### **IN THE DRAWINGS**

Please approve the changes to the drawings in Figures 1, 5, 7, 8, and 11, as outlined in the attached Letter to the Draftsperson, and as shown in the accompanying revised replacement drawings.

FIG.1

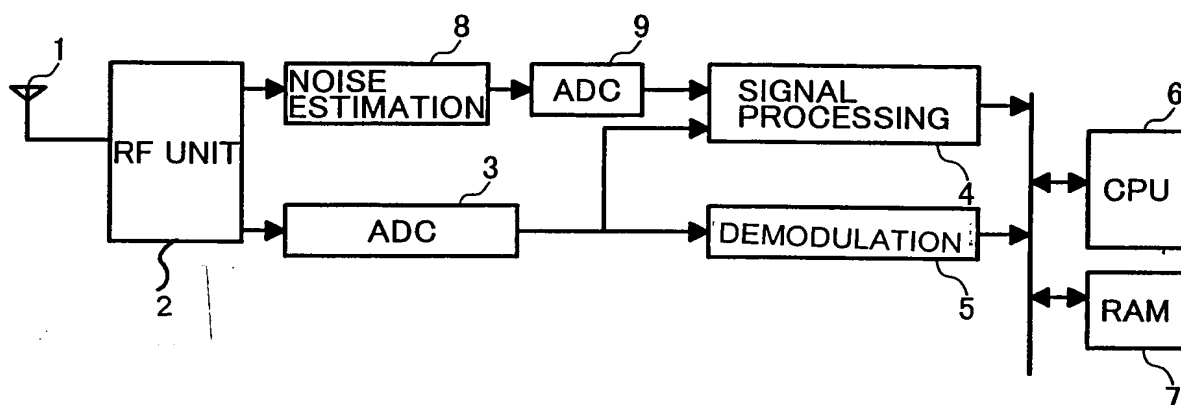
Specifically, in Figure 1, the numeral 2 and lead line therefor have been added and the spelling of the word “demodulation” has been corrected.

FIG.5

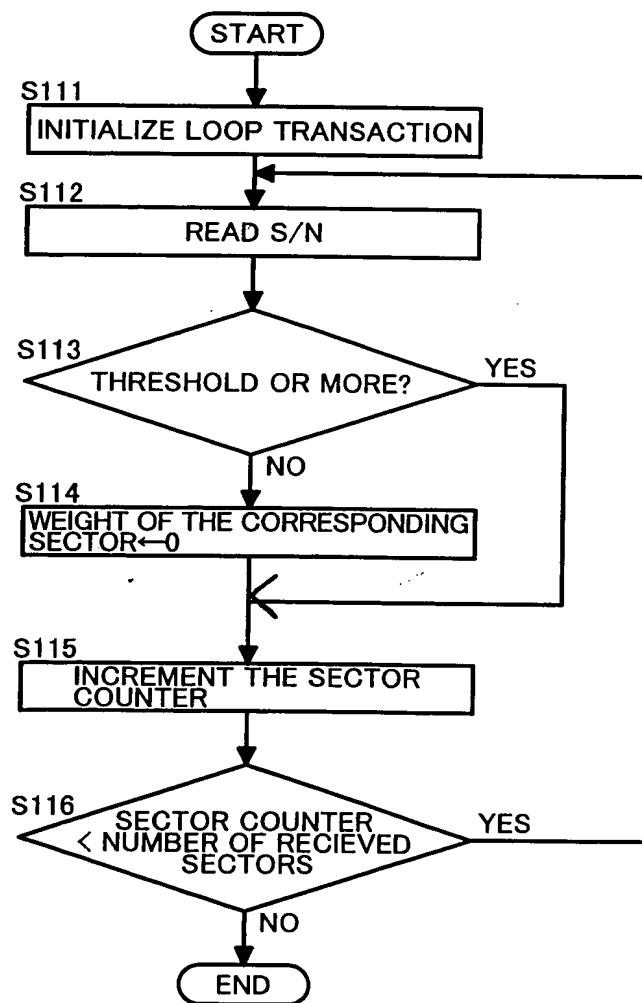
In Figure 5, an arrowhead has been added to a line from the decision block for S113.

FIG.7

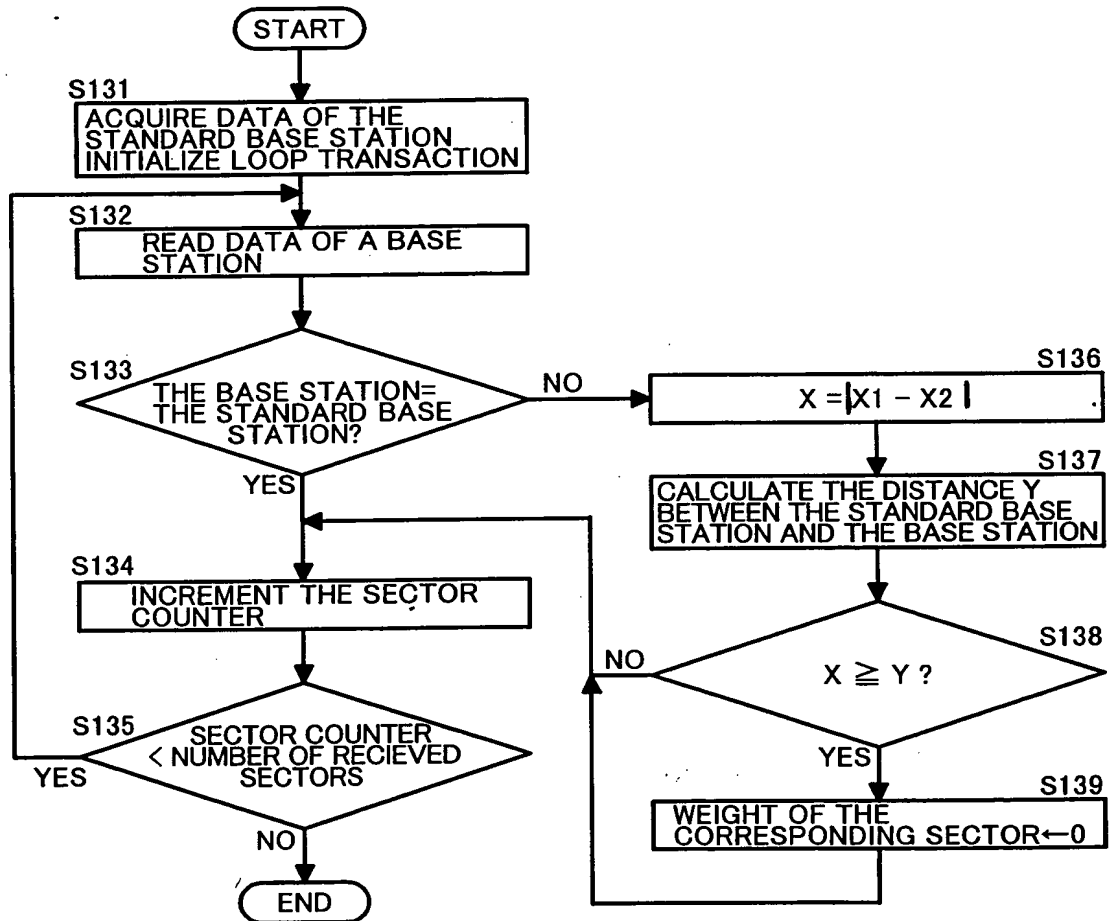
In Figure 7, absolute value lines have been added in the block for step S136.

FIG.8

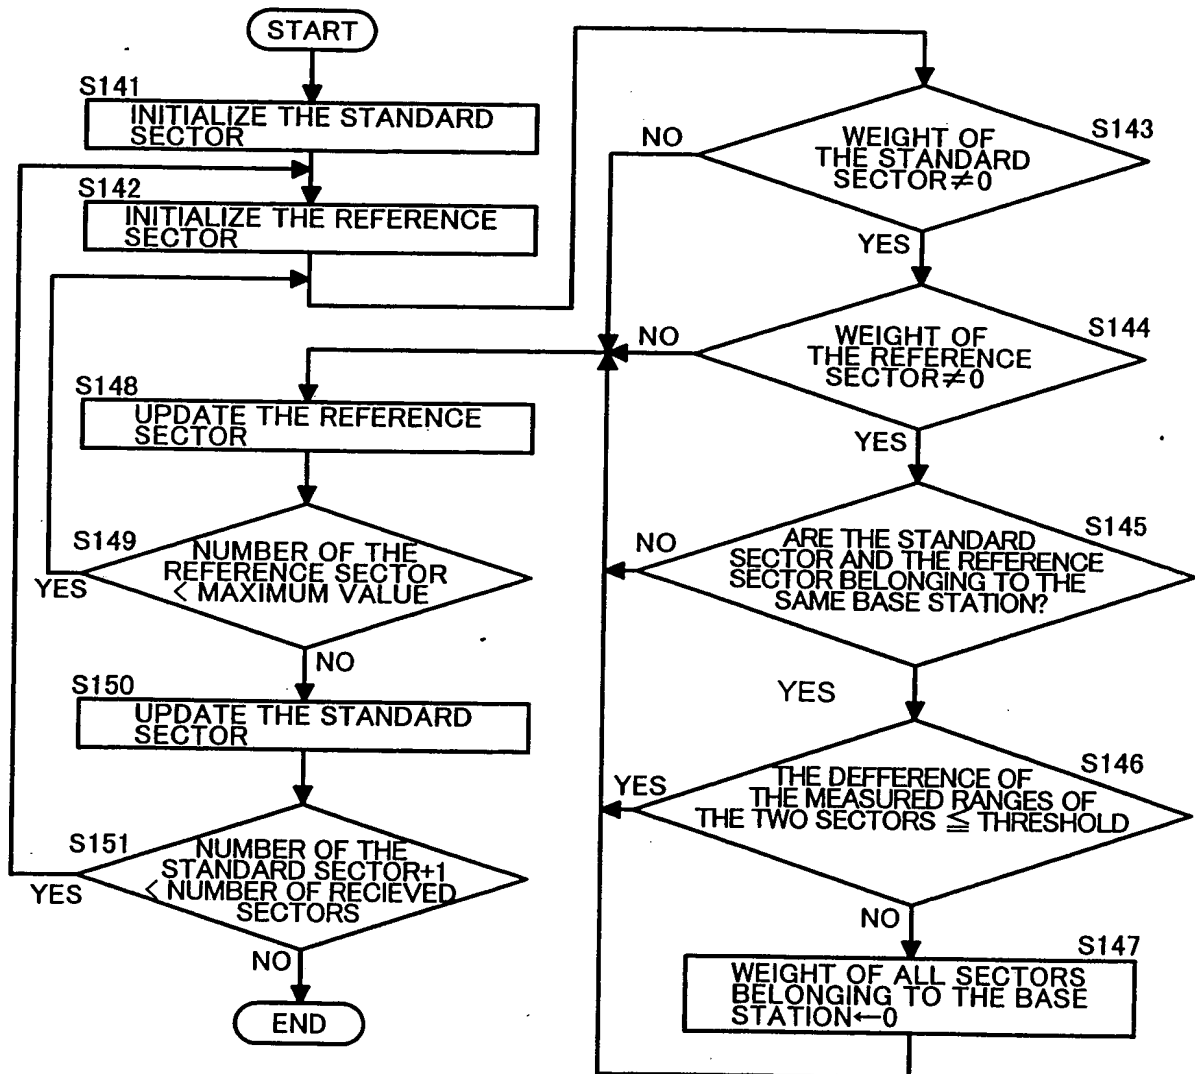
In Figure 8, the word “yes” has been added to identify a line from the decision block for step S145.
